**Comanche Peak Nuclear Power Plant, Units 3 & 4
COL Application**

FSAR Revision1

Update Tracking Report

Revision 8

Figure 11.2-201 Liquid Waste Management System Piping and Instrumentation Diagram (Sheet 2 of 10)

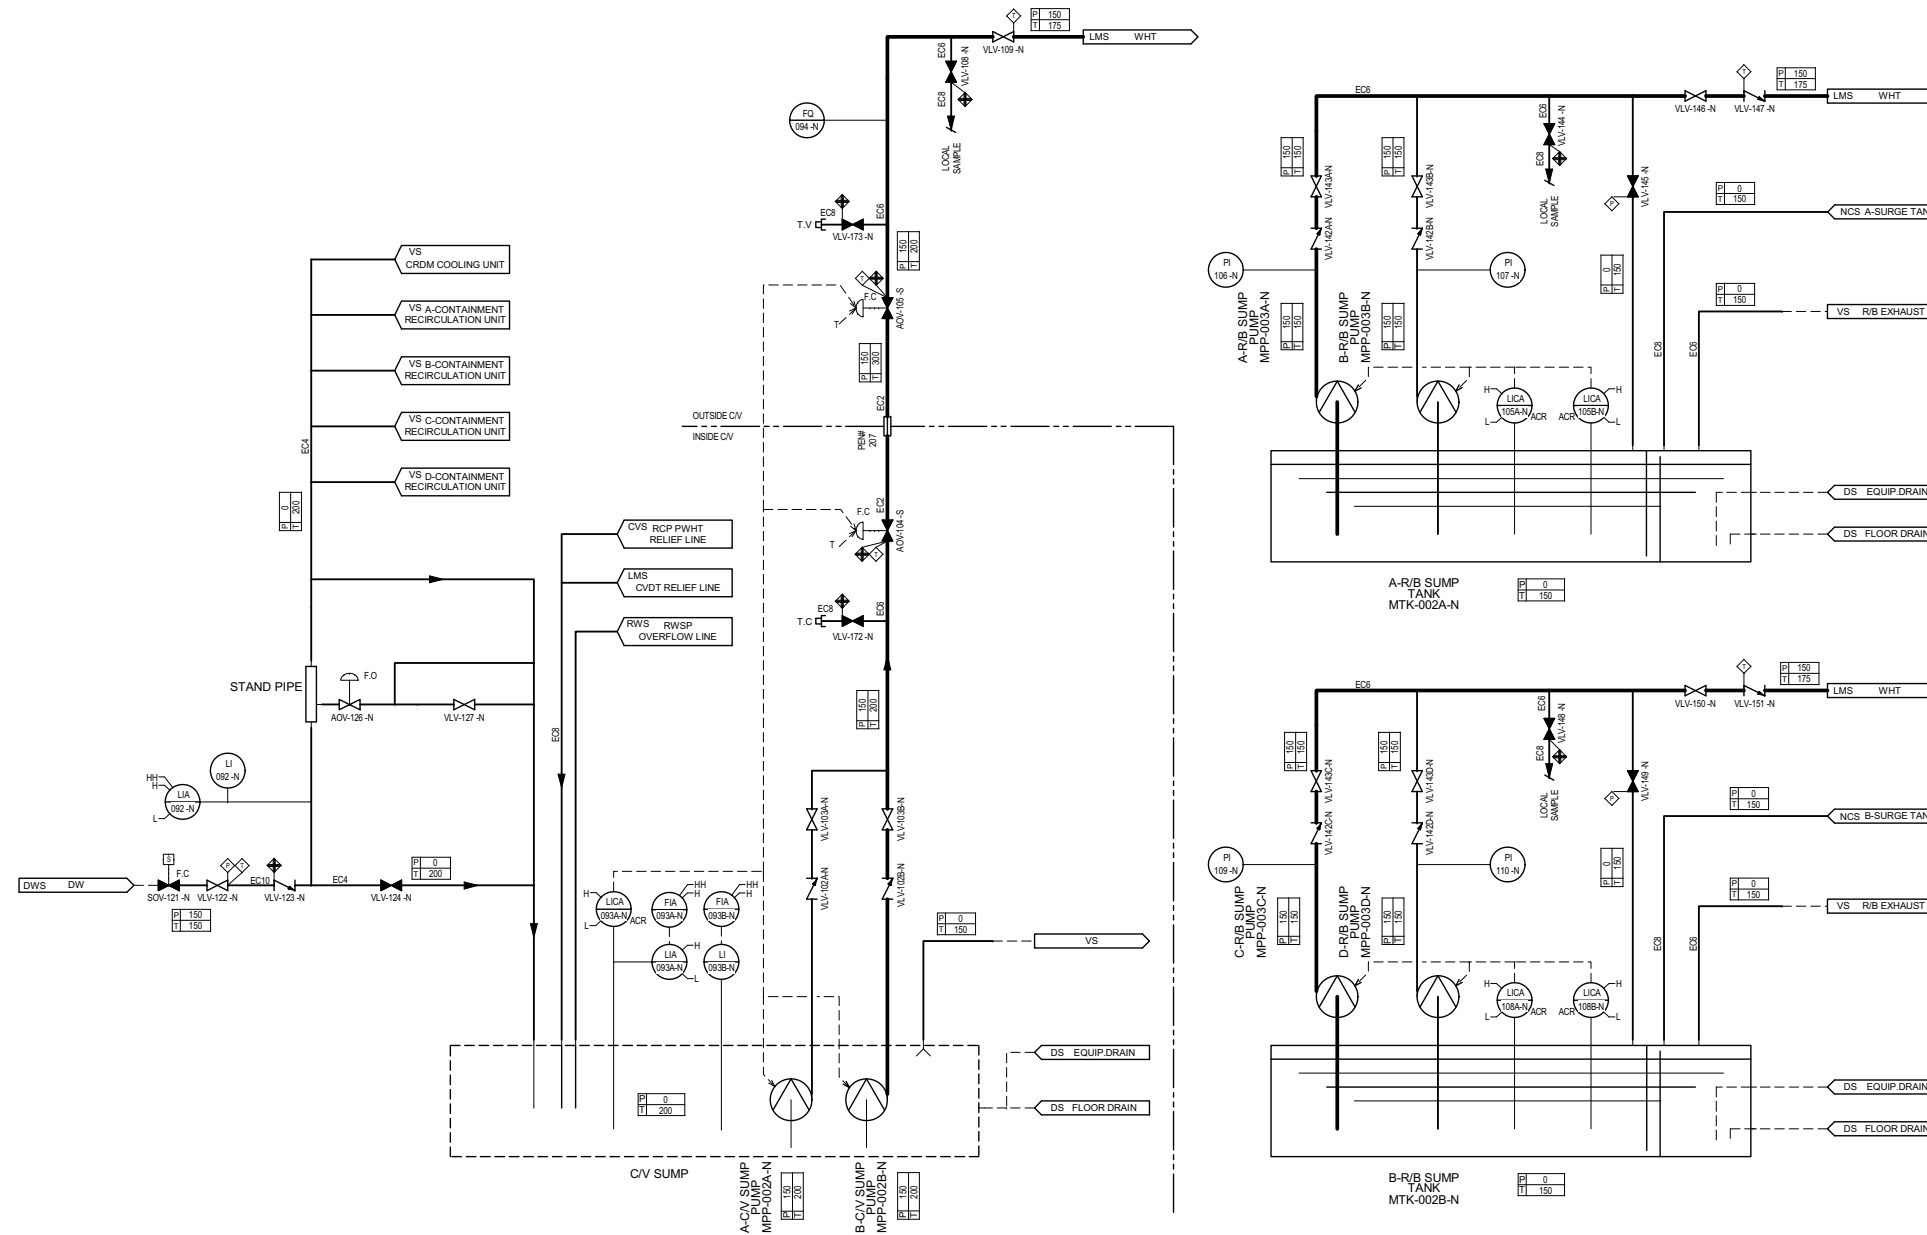
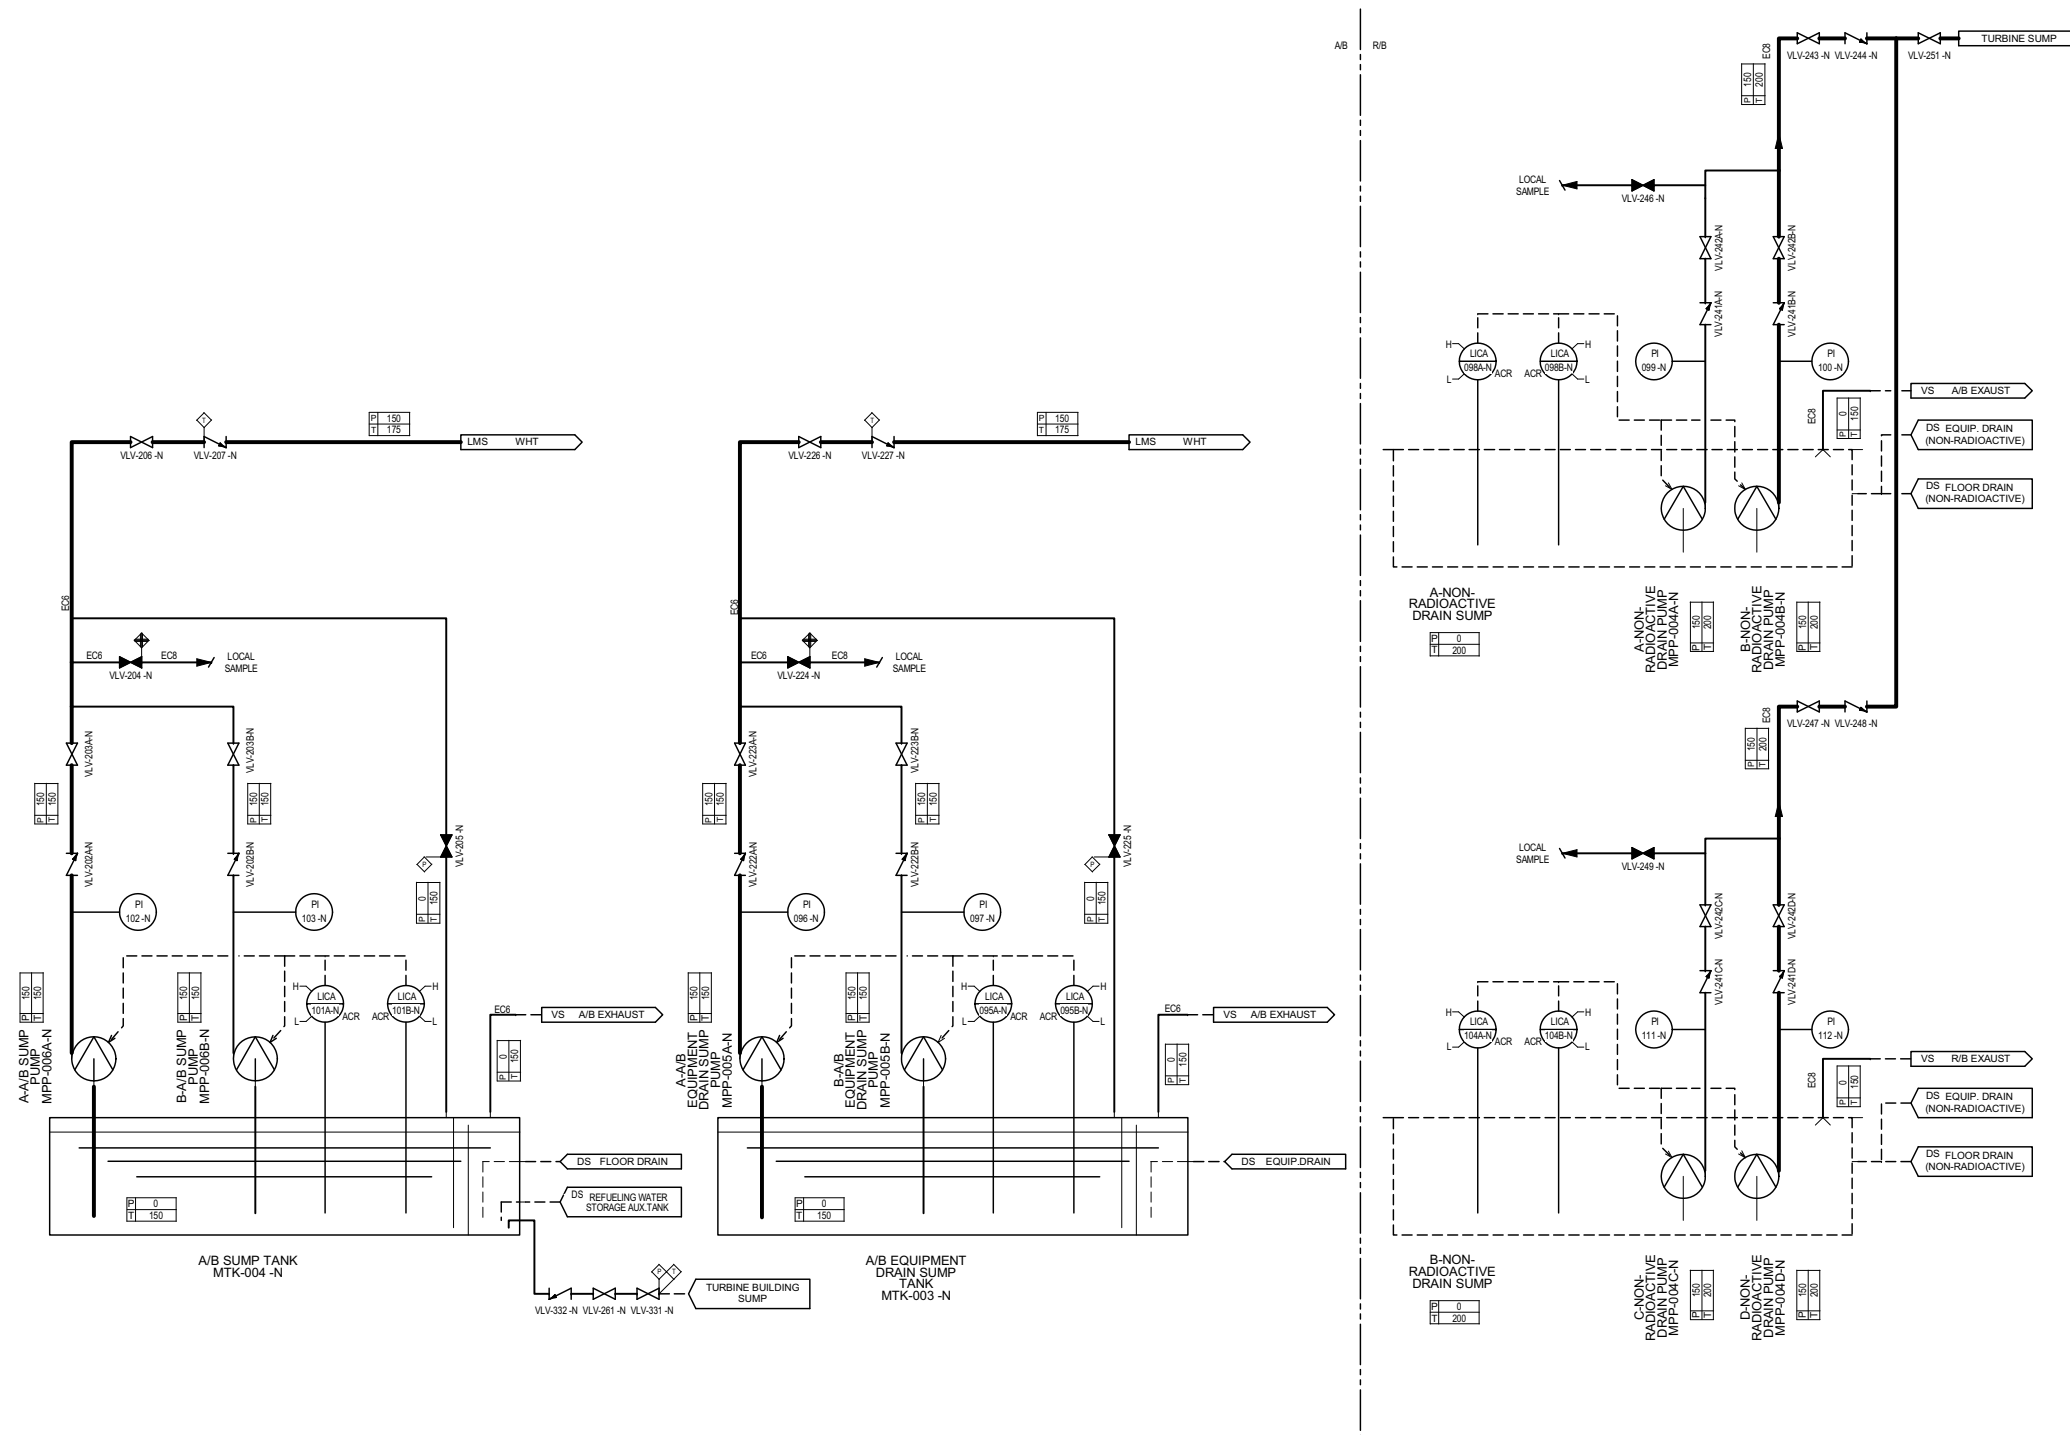
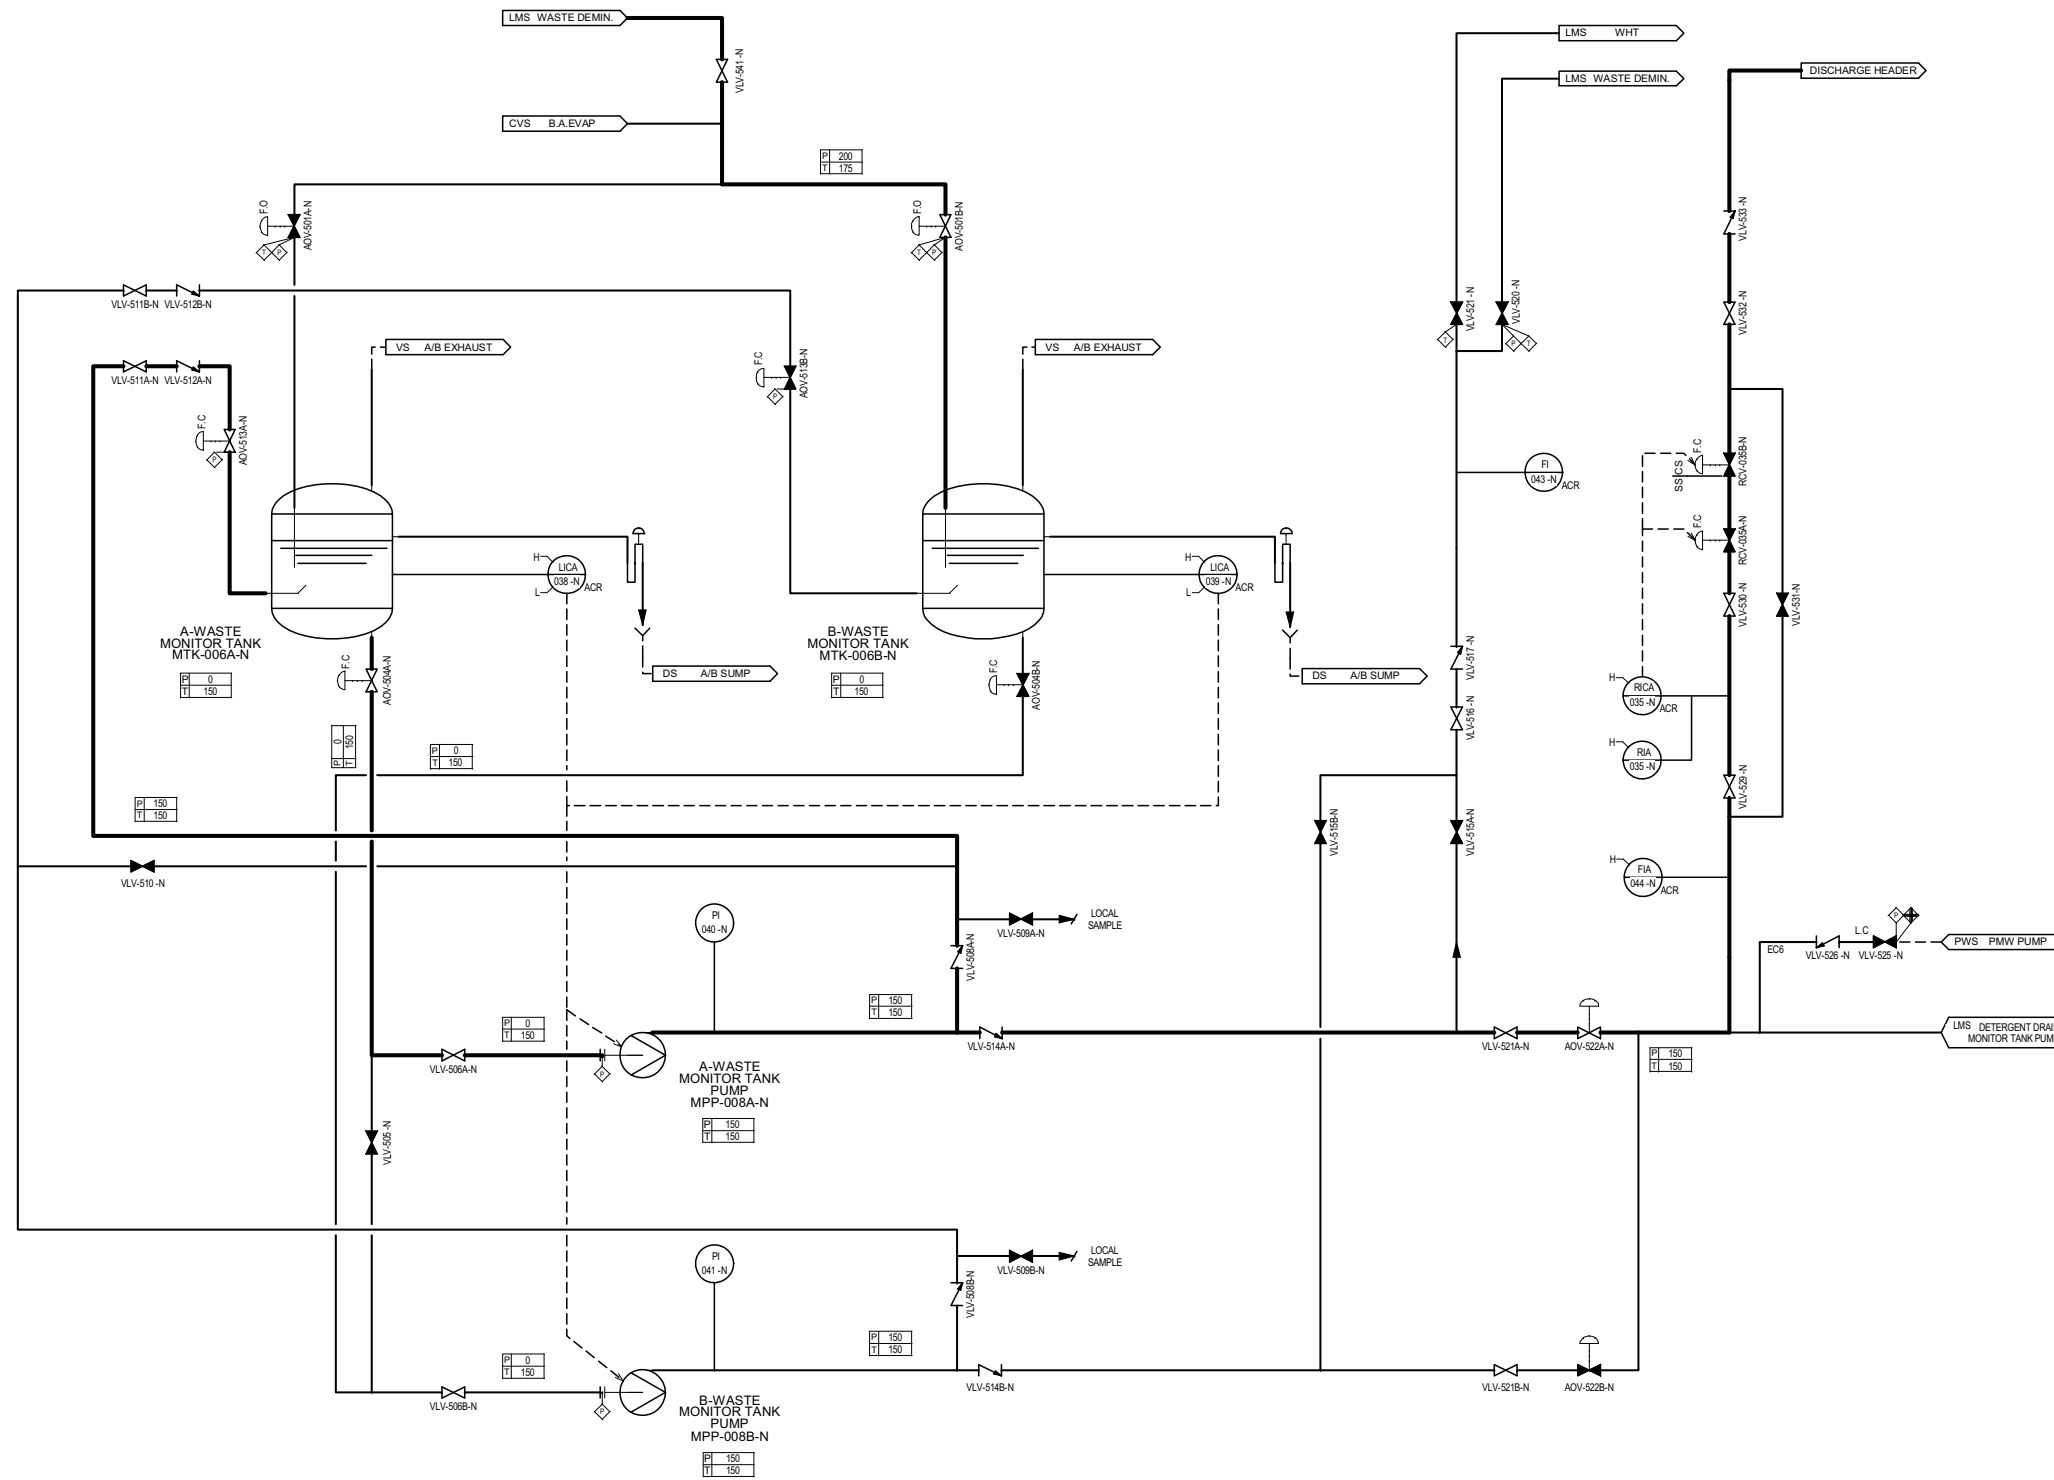
MAP-11-308	Figure 11.2-201 (Sheet 1 through 9 of 10)	11.2-21 through 11.2-29 [11.2-27 through 11.2-35]	simplified P&ID	Replaced the figures with simplified P&IDs	6
MAP-11-309	Figure	11.3-12	simplified P&ID	Replaced the figures	6
